MARTINS CREEK QUARRY EXPANSION SSD 14-6612

I object to the project as described in the EIS.

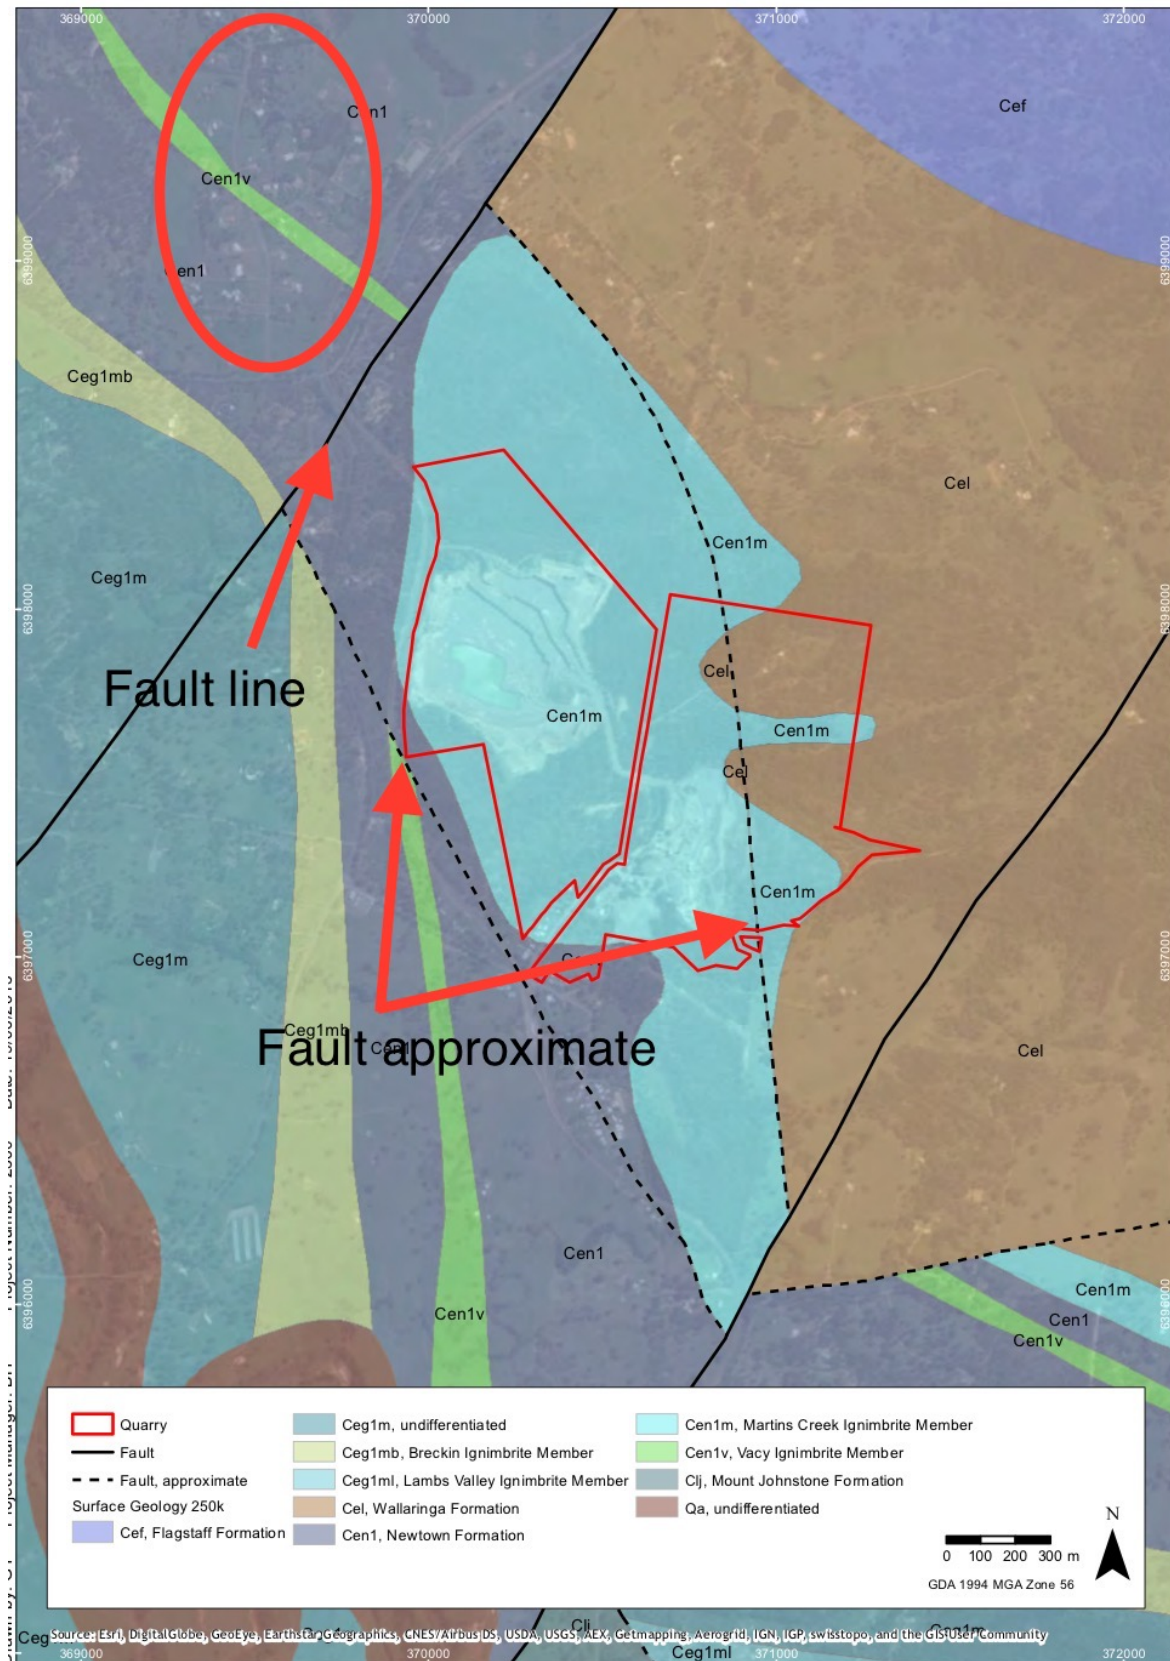
What area (radius) around the blast monitor is the blast result relevant to?

The blast result for Paterson Valley Estate on 21/10/16 reported PPV 1.75, Overpressure 94.9 is not credible.

Blast results for 4/5/15 list PPV for all 3 monitors as .89, is that correct?

If the bubble is not within the black circle of the geophone what effect does that have on the reading? (Texcel GTM blast monitor)

Since Paterson Valley Estate (marked on map) is on 2 different strata Vacy Ignimbrite(Cln) and Newtown Volcanics (Cln) to the quarry, what method of coupling of the geophone does the author think appropriate?
